In the Drawings

REMARKS

Applicant thanks the Examiner for his comments in the Office Action dated May 13, 2005.

FIG. 1

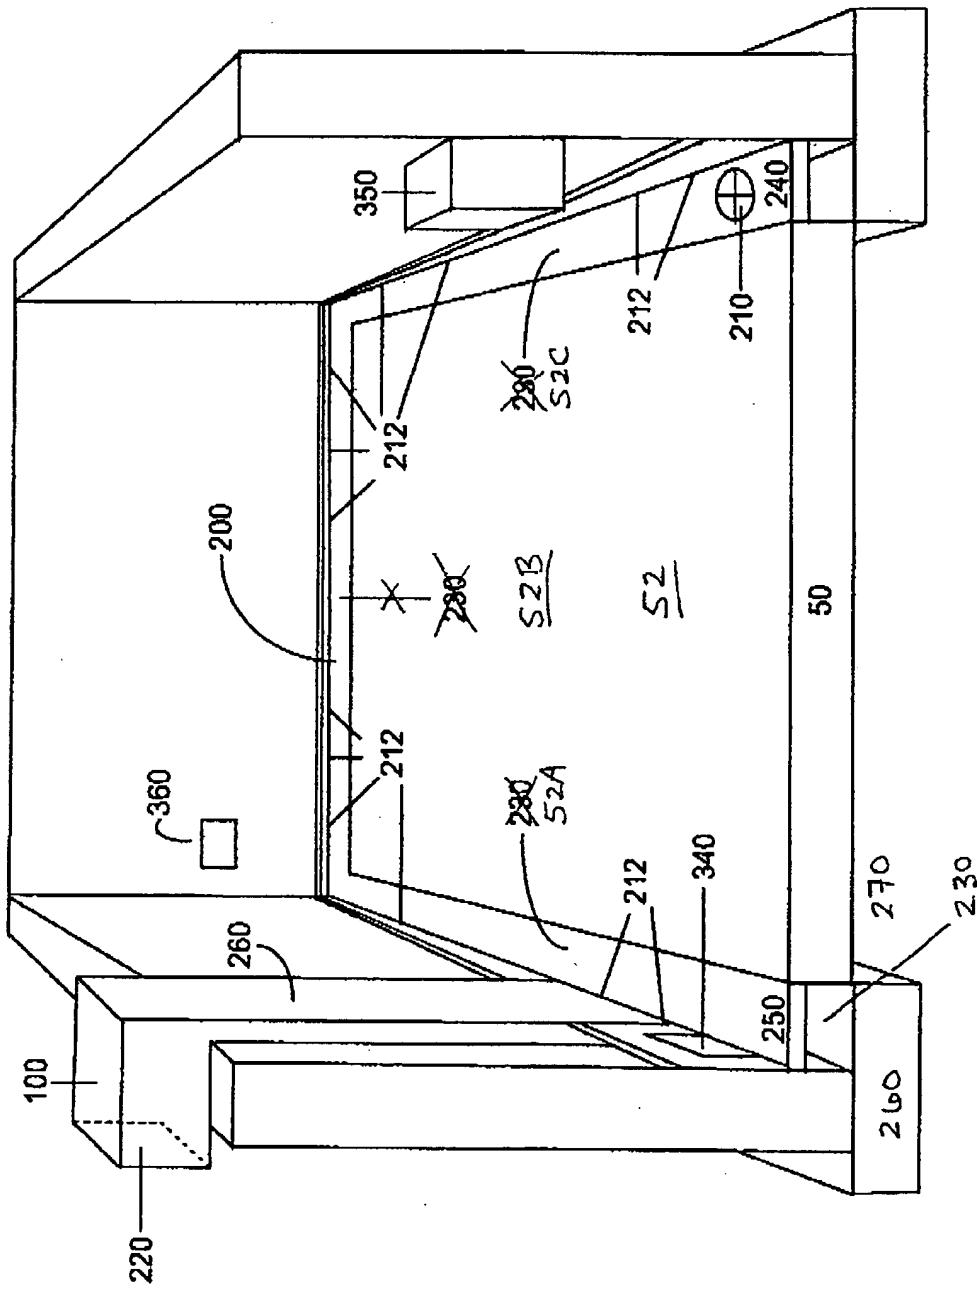
Applicant has modified Fig. 1 to further define a preferred embodiment of the invention identifying that floor 52 exists above the sub floor 50 and that the drainage system is located underneath the basement floor in the proximity of the location where the wall rests on the foundation. Further with these modifications, Applicant believes that the 112 rejections presented for claims 1-3, 10, and 13 have been overcome.

Replacement drawings showing these features are included with mark-ups.
